LIST OF PROPOSED CHANGES:

THE MEADOWLANDS - PROPOSED SITE PLAN CHANGES

BUILDING 1 & 2
 PROPOSED CHANGES - FLOOR PLAN

1 WEST ELEVATION - BLDG 4 - PROPOSED DESIGN
PR3.4 1/8" = 1'-0"

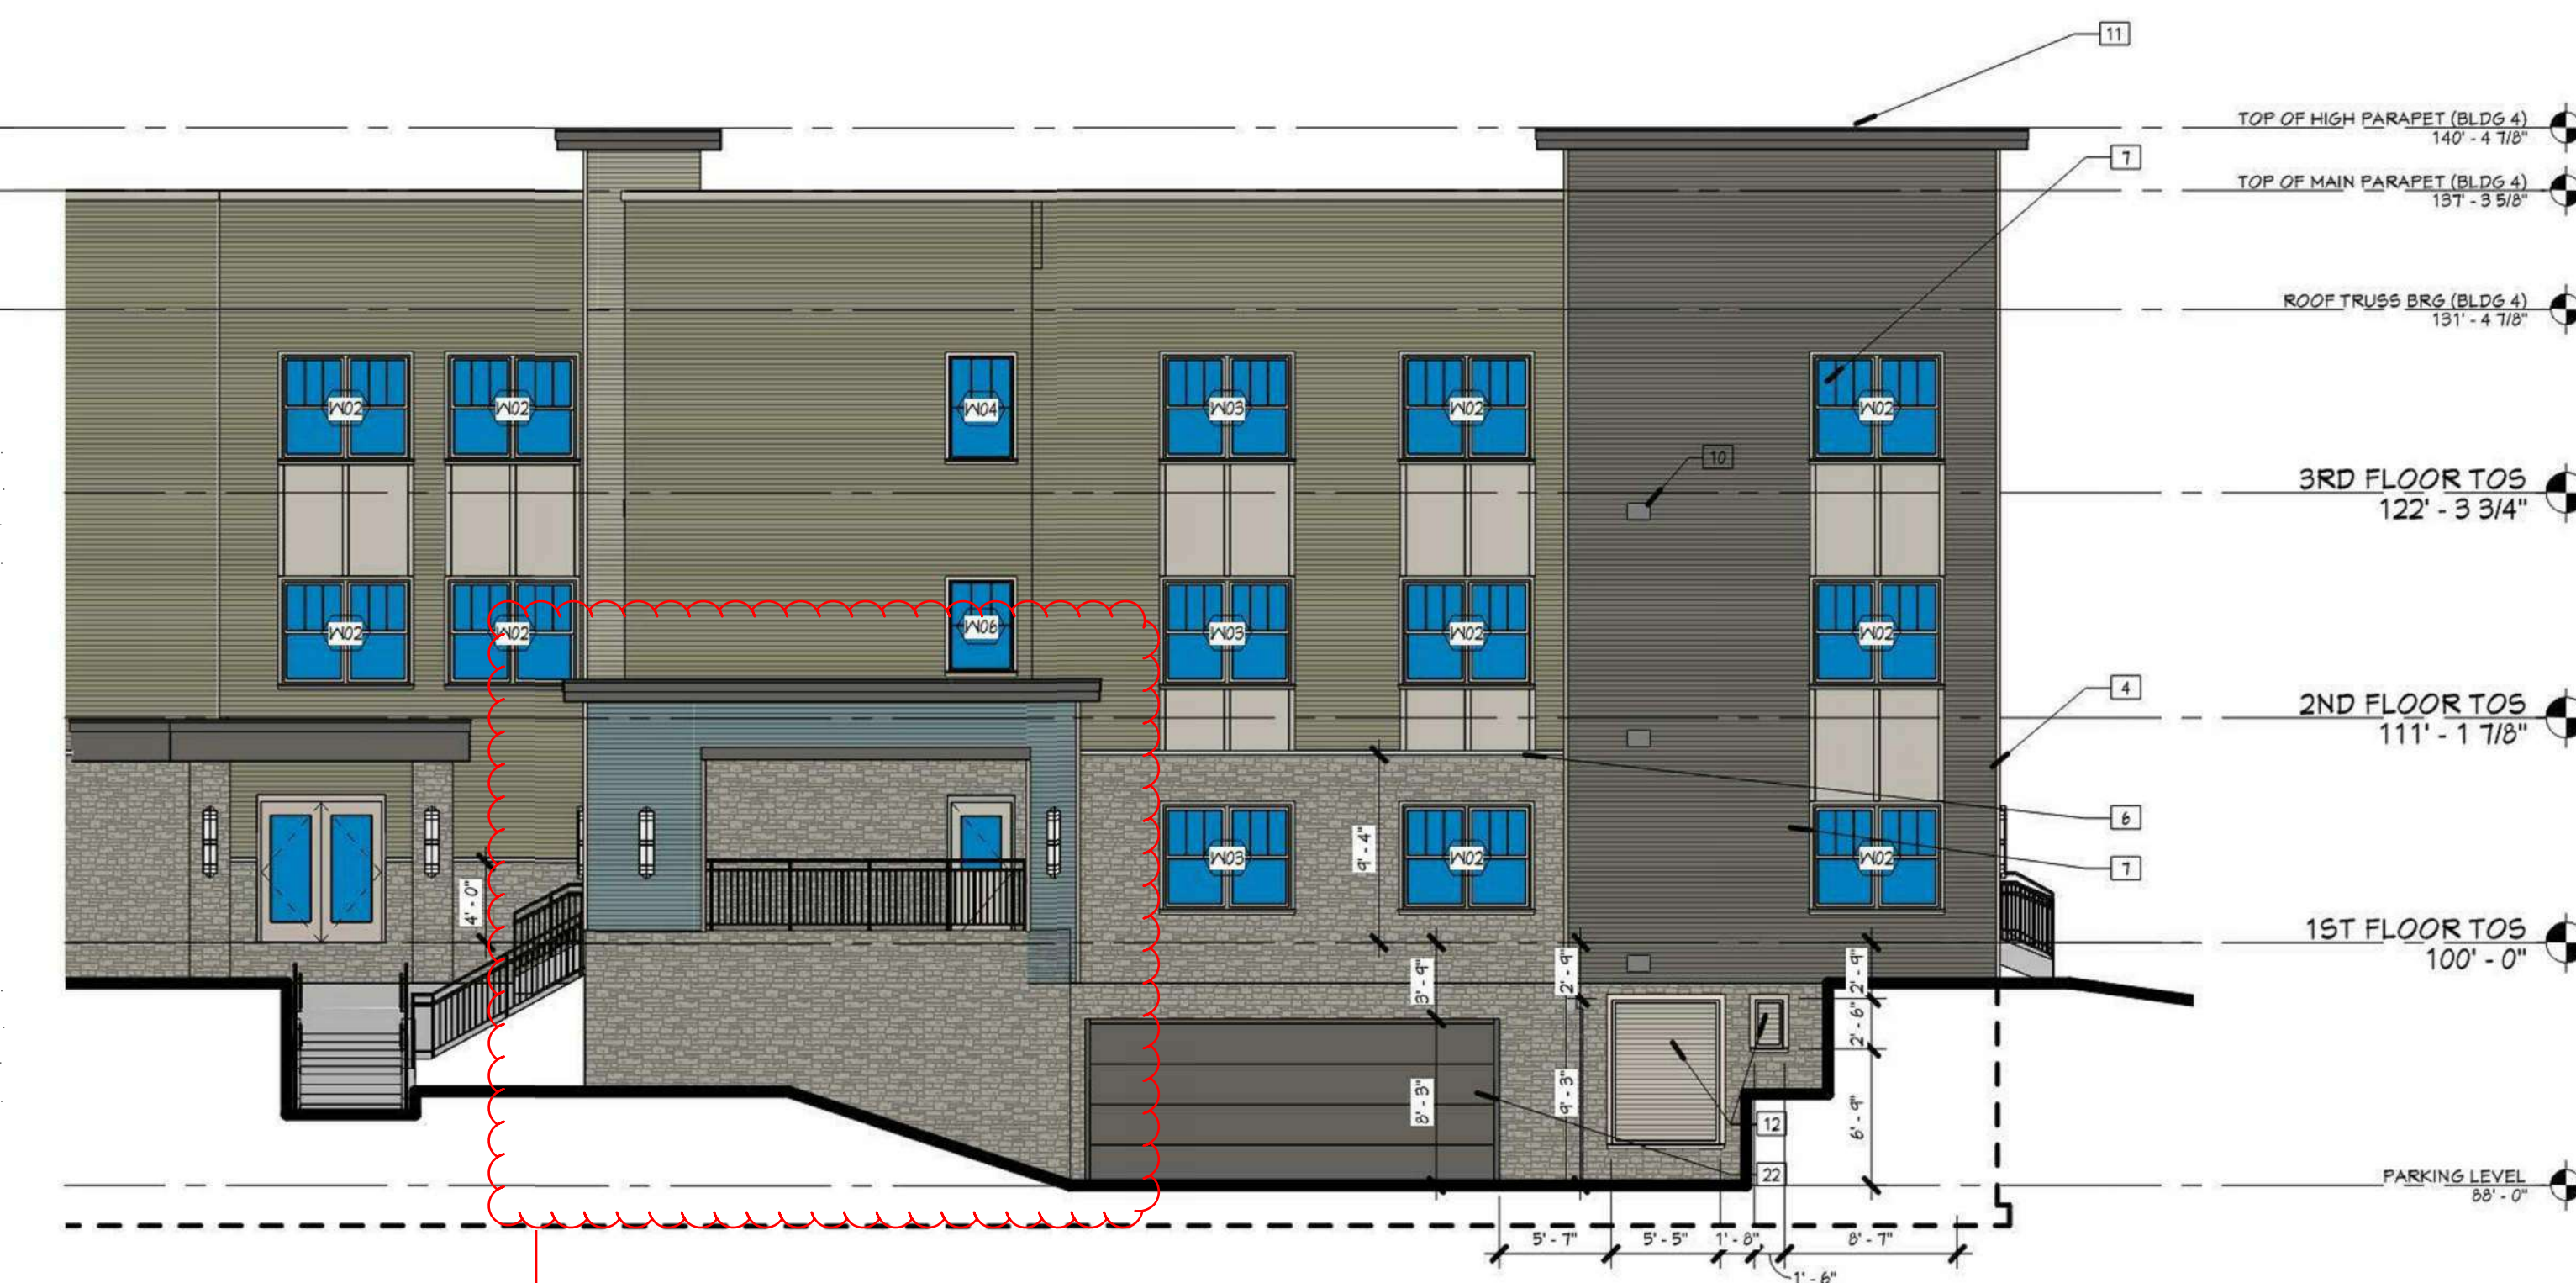
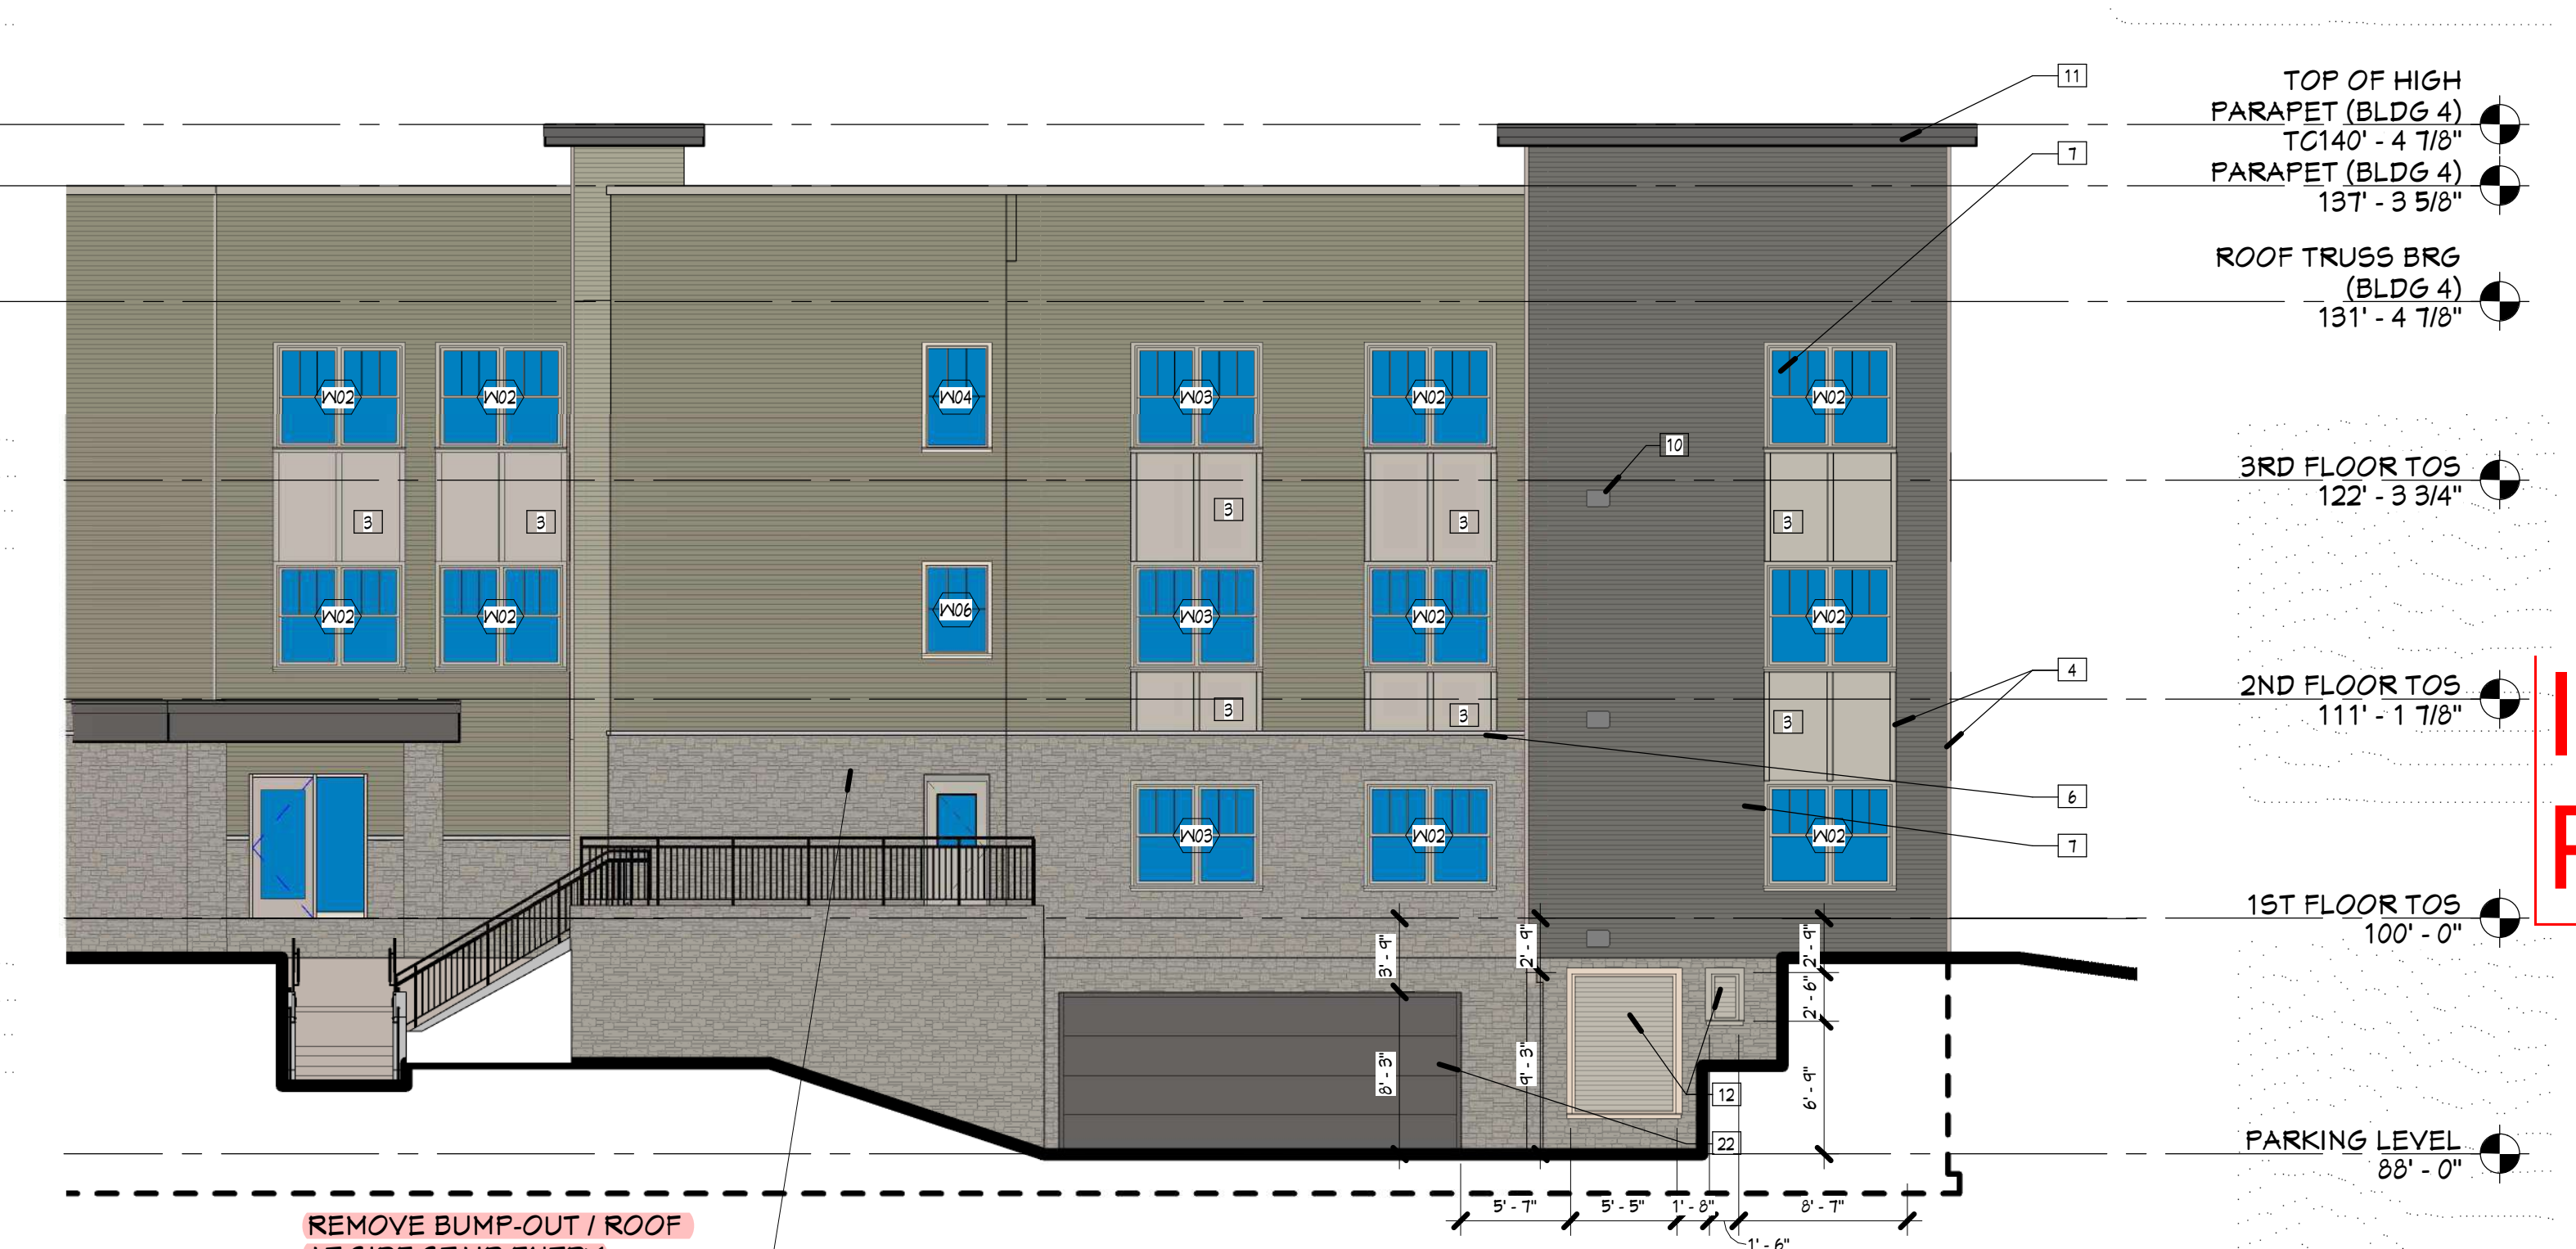
REMOVE BUMP-OUT / ROOF AT SIDE STAIR ENTRY (AT BUILDING ENDS ONLY)

REMOVE STEPS TO PATIO AND SIDEWALK TO STREET SIDEWALK

REMOVE BUMP-OUT / ROOF AT SIDE STAIR ENTRY (AT BUILDING ENDS ONLY)

PROPOSED RETAINING WALL AND PATIO OVERALL PLAN

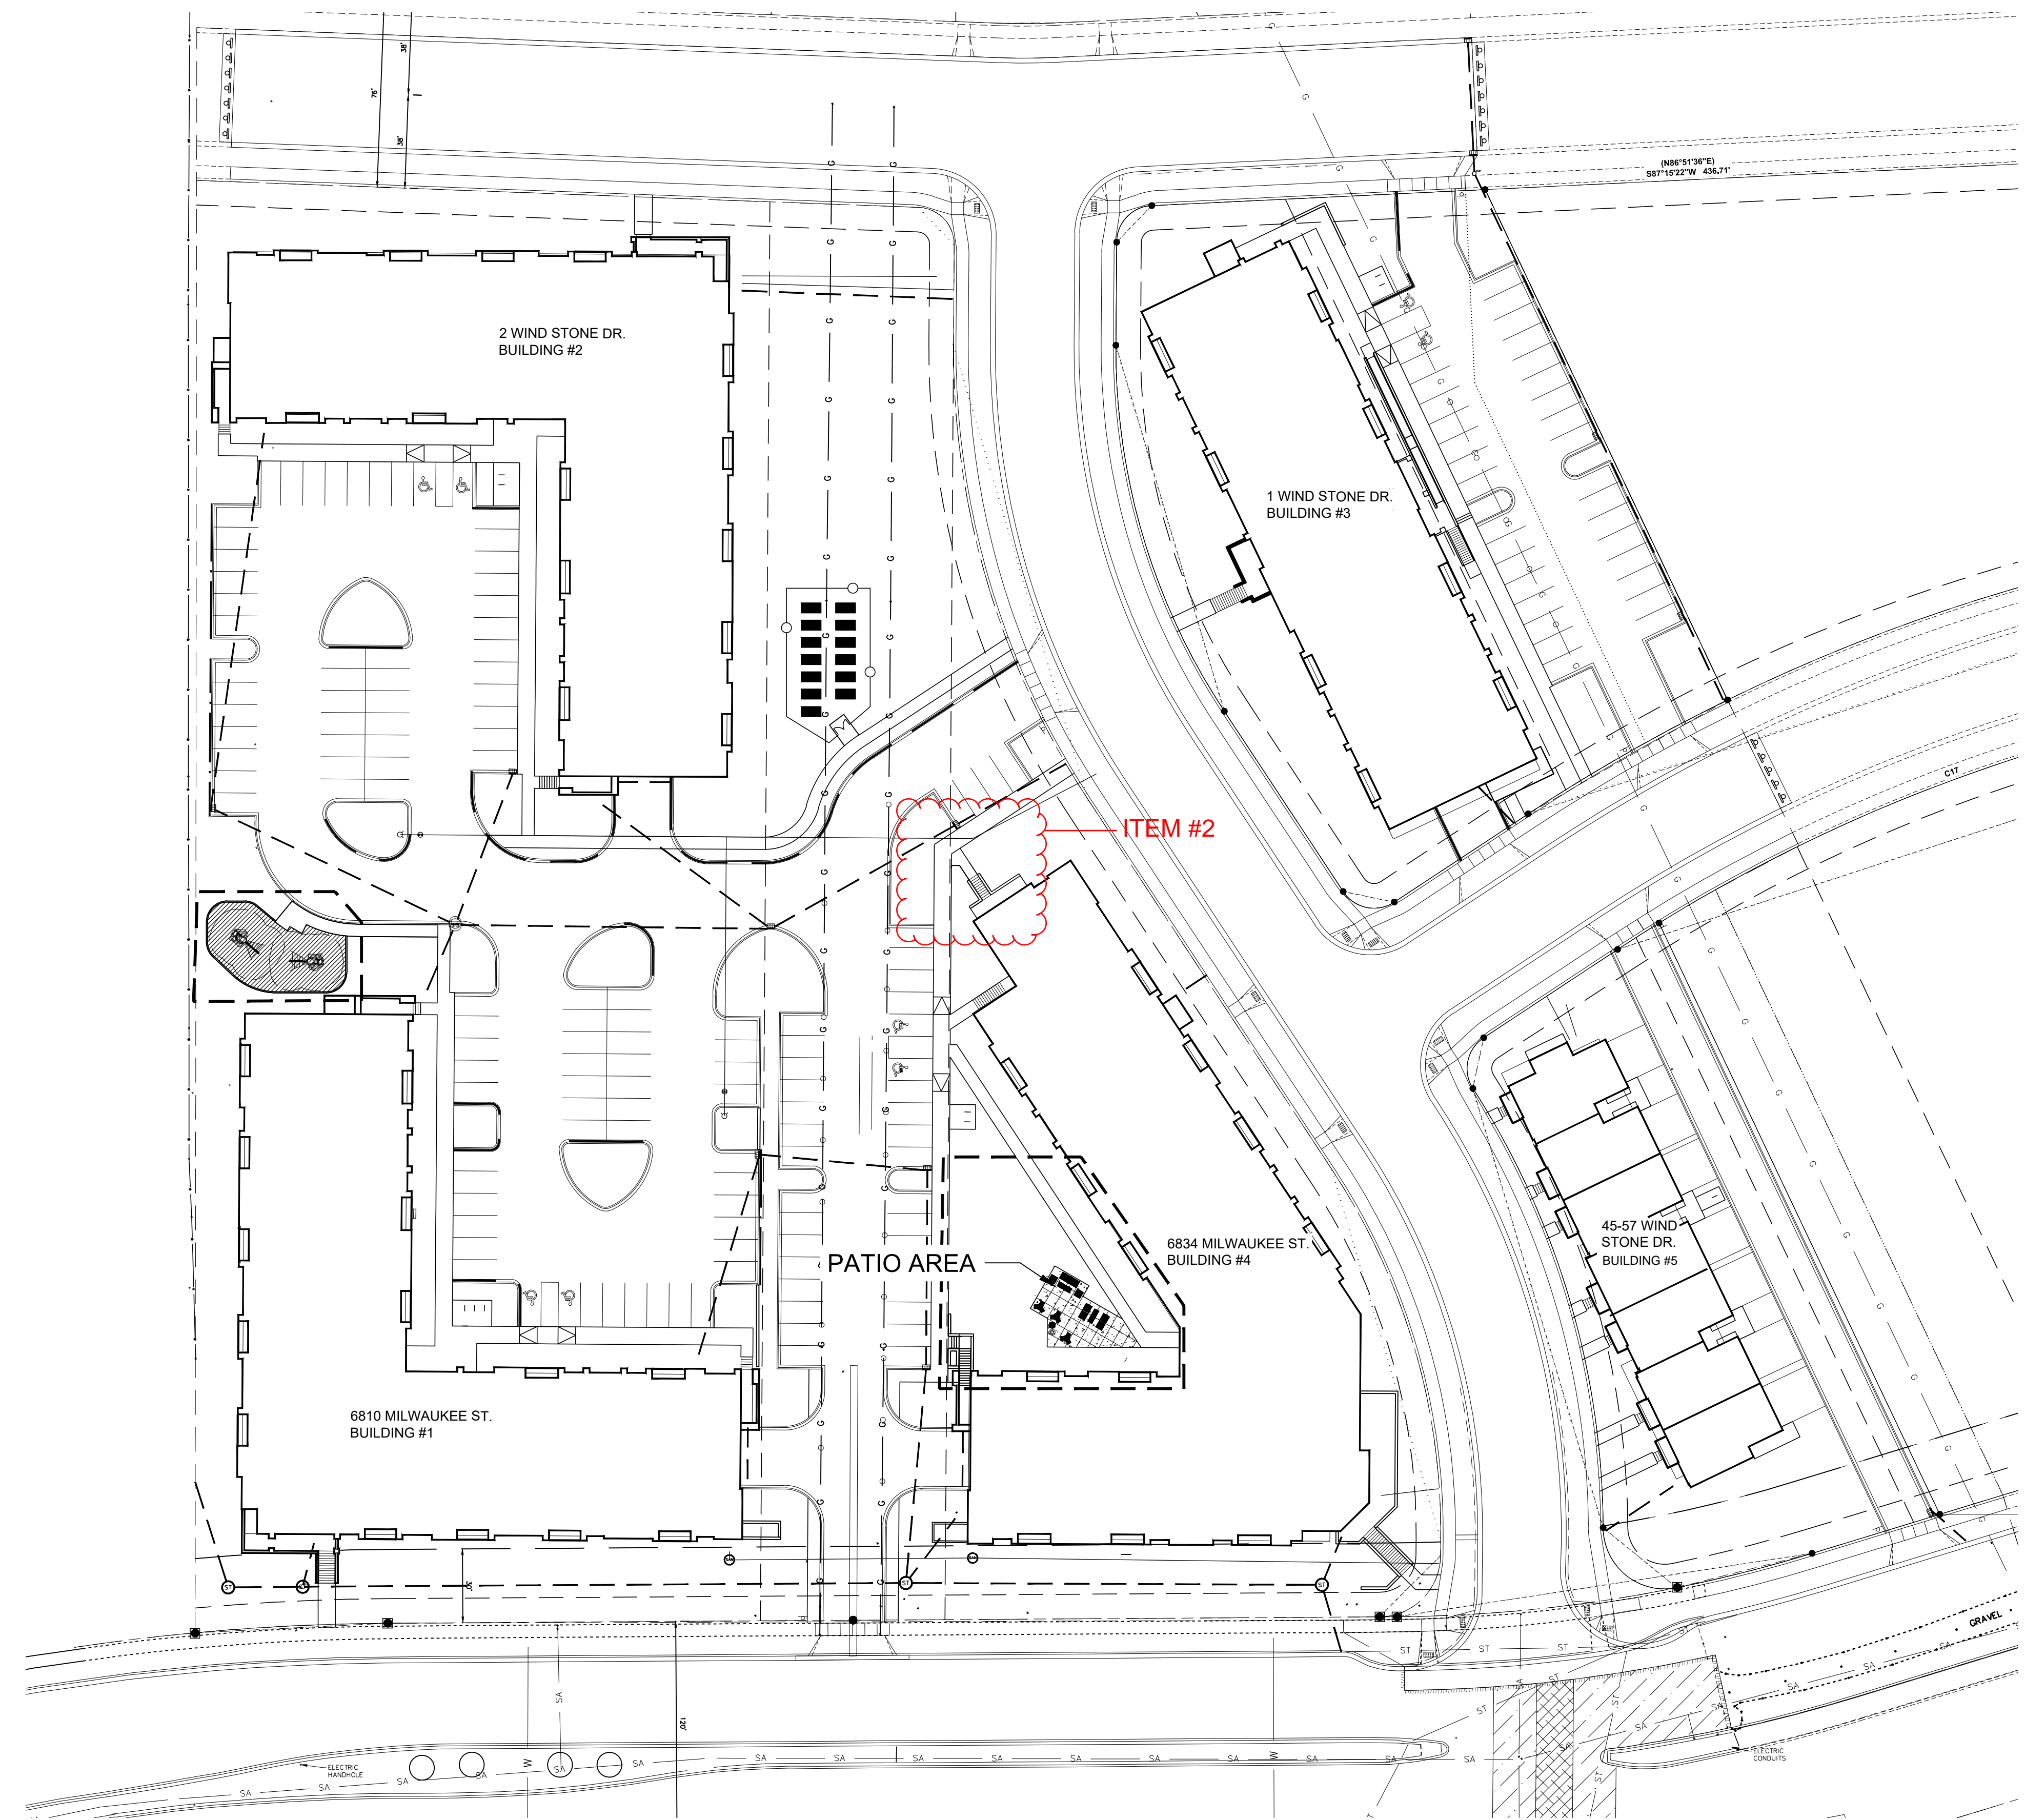
ITEM 2:
REMOVE RAMP TO HUMAN SERVICES OFFICE ON NORTH SIDE OF BUILDING #4. ACCESSIBLE ACCESS PROVIDE FROM MAIN ENTRY AND BUILDING CORRIDORS.
